CALIFORNIA COASTAL COMMISSION

Prepared January 9, 2013 for January 10, 2013 Hearing

**Subject: STAFF REPORT ADDENDUM for Th22a
Appeal Number A-3-SLO-11-061 (McCarthy Residential Development)**

ORIGINAL RESIDENCE DESIGN AND LOCATION

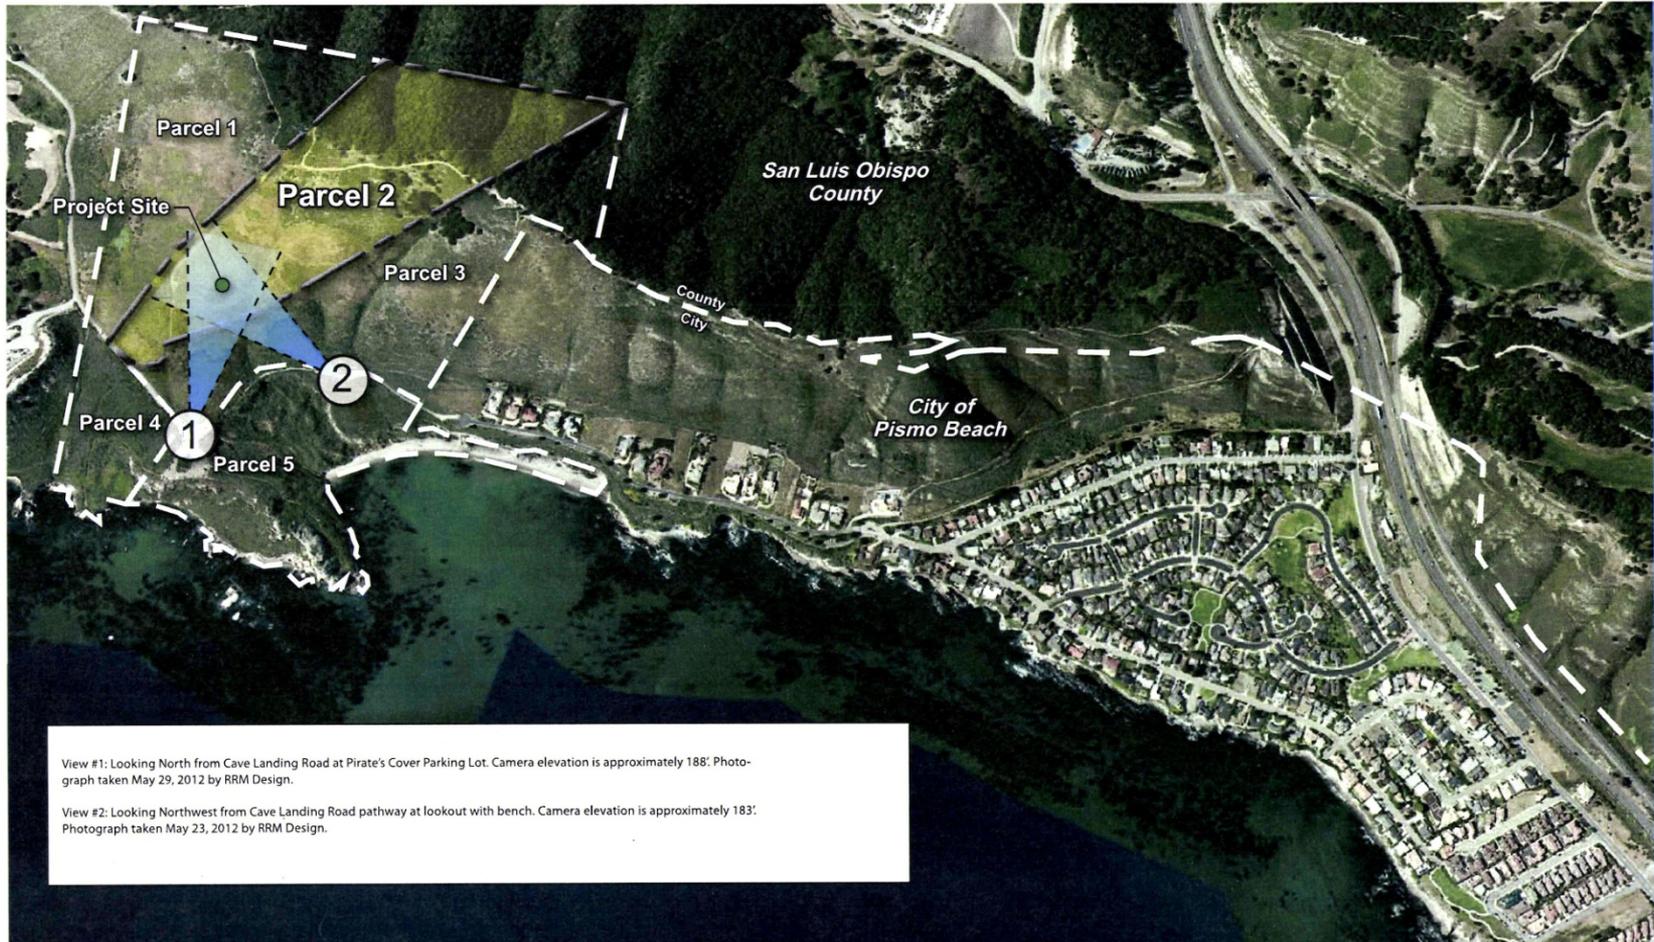
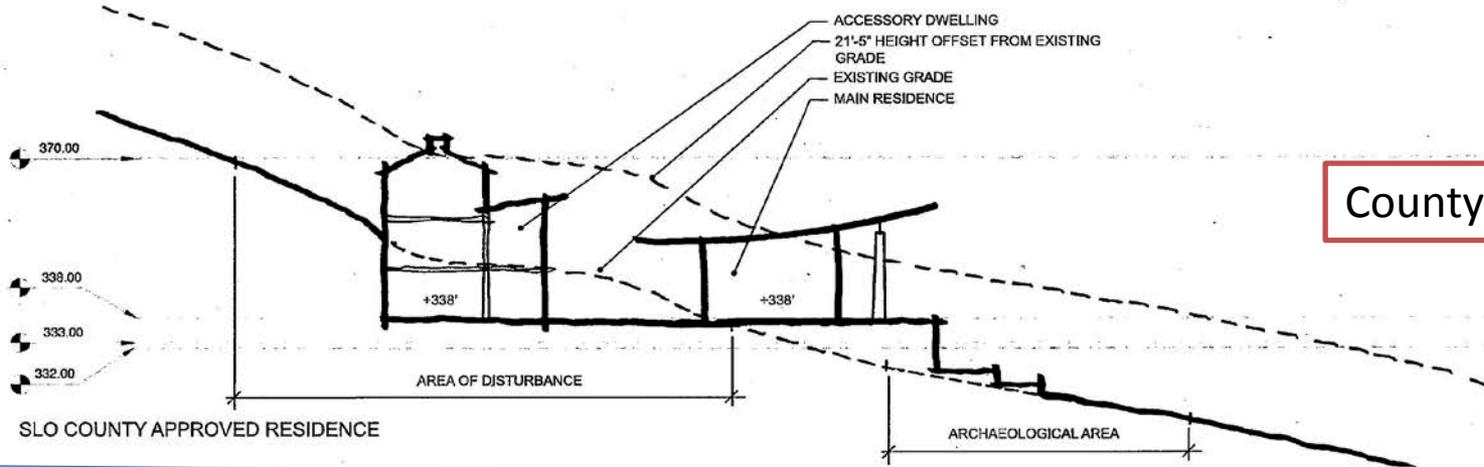
MODIFIED RESIDENCE DESIGN AND LOCATION:

1. RESIDENCE FOOTPRINT REDUCED IN SIZE AND RELOCATED TO FIT WITHIN AREA OF DISTURBANCE.
2. RESIDENCE FINISH FLOOR LOWERED AND RECESSED FURTHER INTO SKARP AREA.
3. RESIDENCE GREAT ROOM ROOF REDESIGNED AND LOWERED.

Revised ASA Avoidance Plan

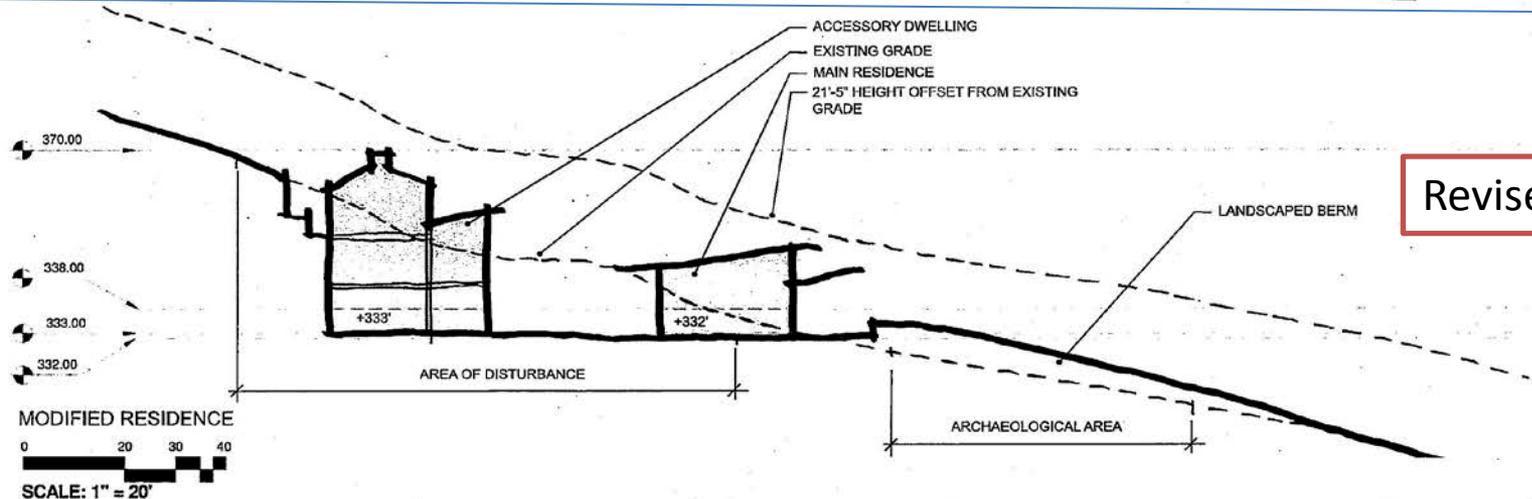
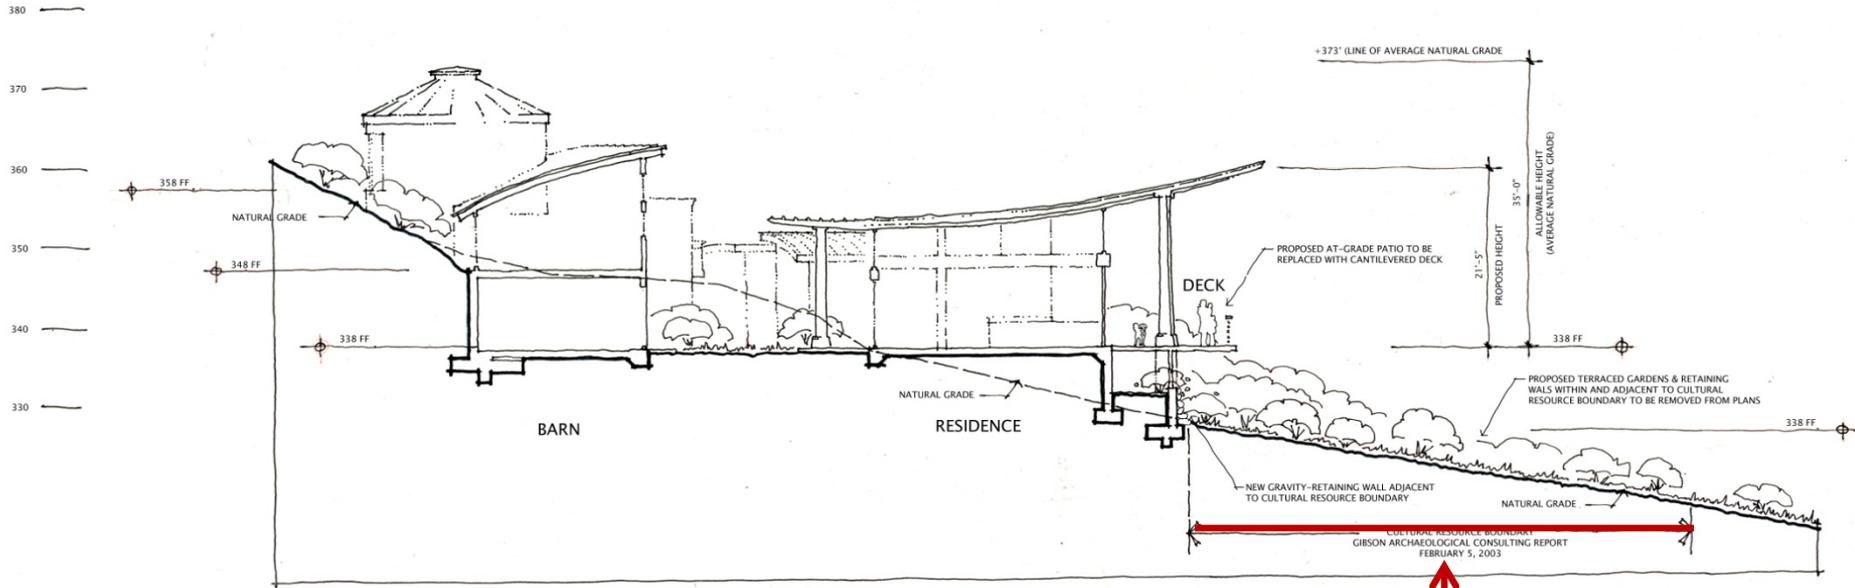
Since the time the County-approved project was appealed to the Commission, the Applicants now indicate that they are willing to totally avoid the ASA. In fact, the Applicants indicate that the proposed patio/deck area can be removed to avoid impacting the ASA area.³⁴ However barring those changes on the final plans, because there are feasible design changes that can avoid the ASA area, the project as proposed cannot be found consistent with the LCP. As indicated above, avoiding disturbance of cultural resources is the highest priority according to the LCP, and a lower priority consists of filling and capping. Thus, consistent with the LCP, this approval is conditioned to avoid the ASA area (see Special Condition 1).
